**Stanley Fairgrounds Stall Barn and MPEC
Bid Addendum #3**

PREPARED FOR
Town of Estes Park
170 MacGregor Ave
Estes Park, CO

January 10, 2013

Addendum #3 includes the following attachments:

PHASE 1 STALL BARN

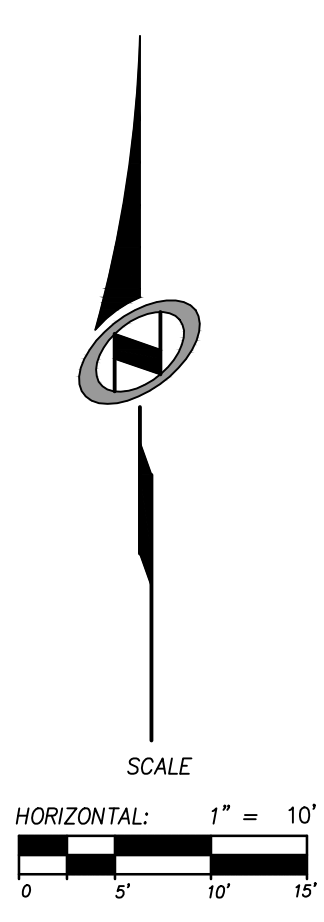
6" CONCRETE SIDEWALK WITH REINFORCEMENT.
SLOPE AT 2% AWAY FROM BUILDING, TYP.
